**SDP26-0010 – Dawson Trails Apartments PA-D
Tract F – Dawson Trails Filing No. 2
4th Submittal – Narrative Update**

Clubhouse Design Updates

Plan Comparisons:

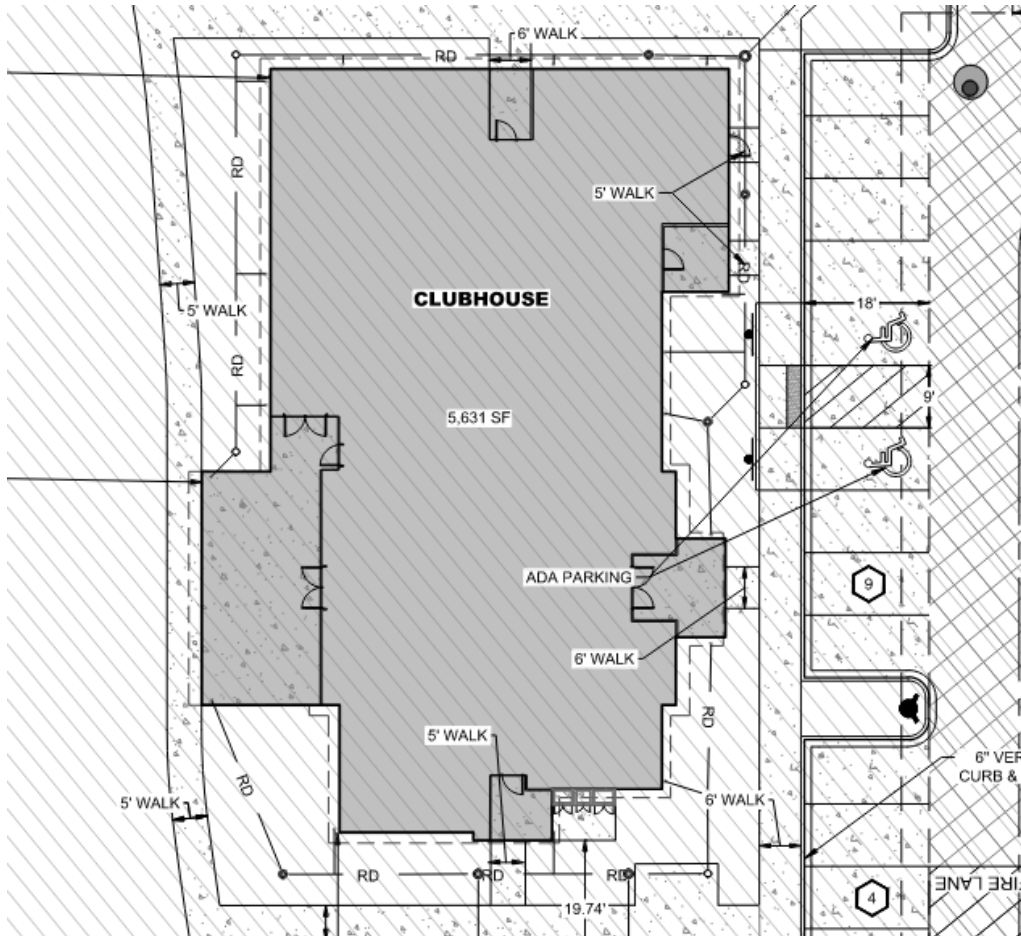
The clubhouse footprint has increased by approximately 240 square feet to accommodate an improved interior layout and enhance the functionality of the space. These changes are reflected in the revised SDP plans and will be incorporated into our next building permit resubmittal.

The clubhouse elevations have also been revised to reflect the updated architectural design. Key changes include:

- Replacement of the previously proposed fiber cement faux timber trusses with exposed heavy timber trusses at the clubhouse entrance and rear elevation (North and South Elevations).
- Addition of an exterior door to provide access to the mail room, along with additional windows and a shade trellis on the North Elevation.
- Replacement of the previously proposed asphalt shingle roof with a standing seam metal roof at the main entrance on the north side of the building

The before-and-after comparisons below illustrate the changes to the clubhouse footprint and architectural elevations between the previous SDP submission and the current resubmittal.
